IN THE MATTER of notices of requirement under section 168 of the RMA for the construction, operation, maintenance and improvement of approximately 11.5km of new State Highway between Ashhurst and Woodville.

**JOINT ADDENDUM TO EVIDENCE OF MARK AARON READ AND DAVID RICHARD MURPHY
ON BEHALF OF PALMERSTON NORTH CITY COUNCIL**

3 April 2019

Figure A.1: Bicycle path operation

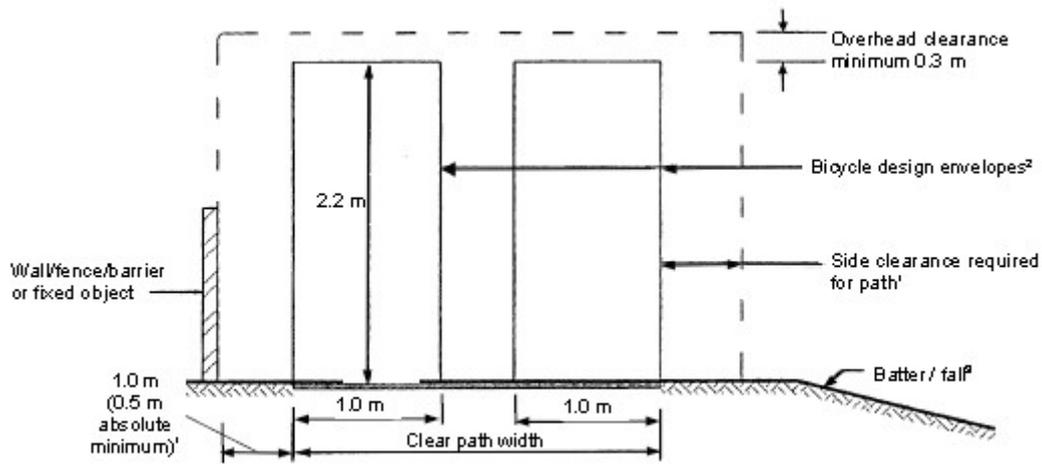
- 4.14** Part 6A, Appendix A, Figure A2: Bicycle Path Operation Scenario C in the Austroads Guide to Road Design¹ recommends best practice for the design of separate paths used by pedestrians and cyclists. For bicycle and shared paths, Austroads recommends *3.0 is the desirable width for a path where high speeds (>30km/h) are possible*. As the majority of the route is on a steep grade, high speeds would be anticipated.

- 4.16** As already discussed a contraflow shared path anything less than 3m will be safety hazard for cyclists passing one another, particularly at corners and where a cyclist is travelling downhill at speed and a cyclist travelling in the opposite direction is travelling uphill (MR).
